**California Transmission Planning Group (CTPG)
Technical Study Team
Response to the August 5, 2011 Comments of the
Bay Area Municipal Transmission Group (BAMx)
on the CTPG's Phase 2 Study Plan**

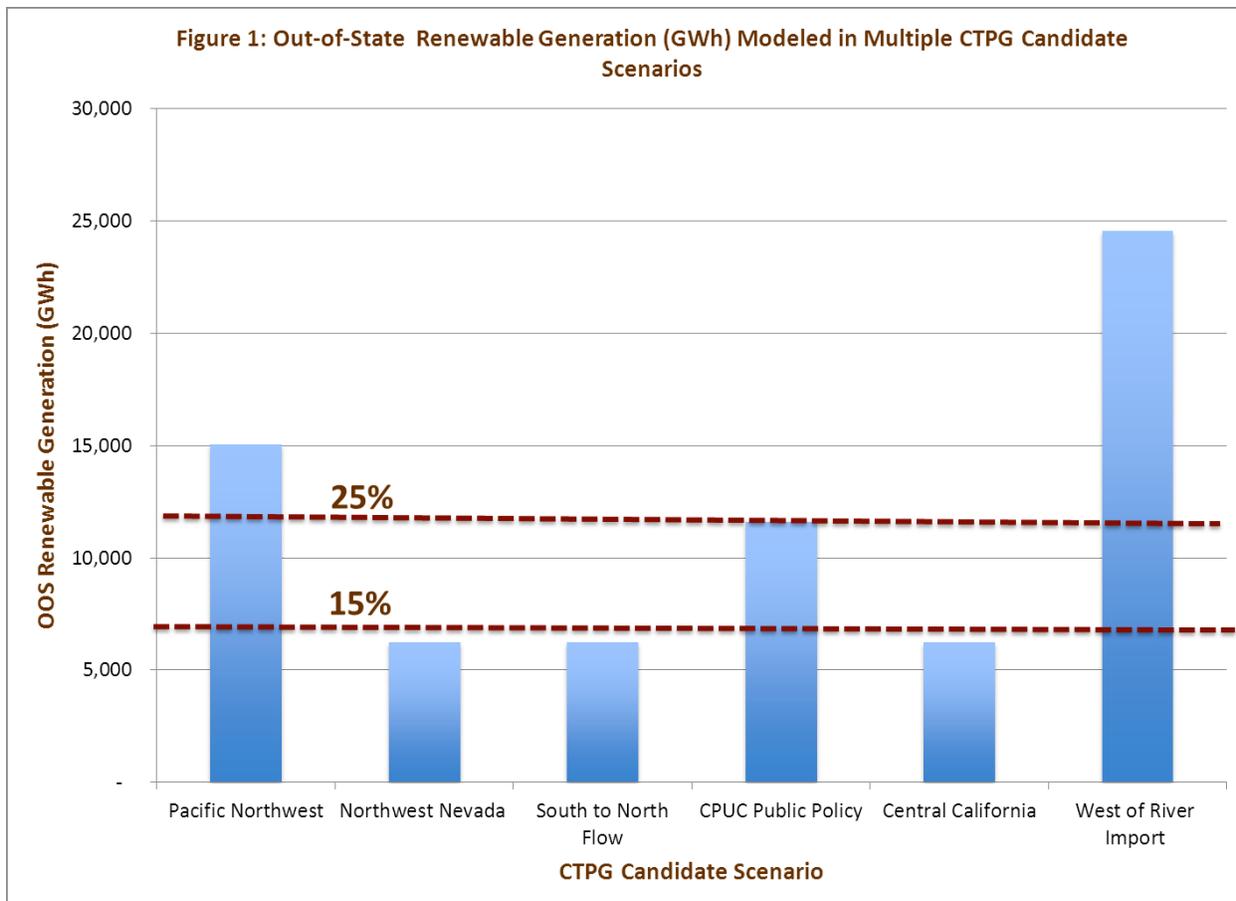
The CTPG has decided to employ the RETI Best CREZ renewable project amounts, except in the case of the CPUC Public Policy scenario (See Table 16 of the Draft Plan). The RETI Best CREZ criterion relies on outdated cost and environmental scores, and has no consideration for utilizing existing and approved transmission in each CREZ. The CPUC has put significant effort into updating the cost, as well as environmental information, originally developed by RETI. CTPG should take advantage of those efforts. The use of RETI Best CREZ criterion ends up adding renewable generation projects that require new transmission. For instance, under the

proposed CTPG approach, the Kramer CREZ had a relatively small amount (584 GWh as shown in Table 22: *Central California Scenario Renewable Dispatch*) of renewable generation in the *Discounted Core*. In order to fill the “net short”, the CTPG has identified a significant amount (1,775 GWh) of additional renewable projects under the RETI Best CREZ criterion from Kramer rather than relying on additional potential resources within CREZs such as Westlands, San Diego South, Tehachapi or Palm Springs, which are already selected by CTPG under the *Discounted Core* criterion for the *Central California* scenario. Each of these CREZs has additional renewable resources under the generation interconnection queue that exceed the amounts identified in this scenario. Furthermore, the renewable projects from the Tehachapi CREZ were artificially restricted to 8,612 GWh, while the RETI Best CREZ approach indicated that Tehachapi CREZ was ranked higher than Kramer CREZ based on both the economic and environmental scores. BAMx strongly urges CTPG to incorporate renewable generation in CREZs that utilize existing/approved transmission infrastructure based on the California ISO generation interconnection queue data.

The CTPG Technical Study Team appreciates BAMx’s perspective that the POU-CPUC Discounted Core should be augmented with additional renewable resources on the basis of CREZs that have “existing/approved transmission infrastructure,” rather than with additional renewable resources from the RETI Best CREZ. On the other hand, the RETI Best CREZ does provide an indication of where economic and environmentally feasible renewable resource development may occur. On balance, the CTPG Technical Study Team continues to believe the RETI Best CREZ provides a reasonable platform from which to augment the POU-CPUC Discounted Core.
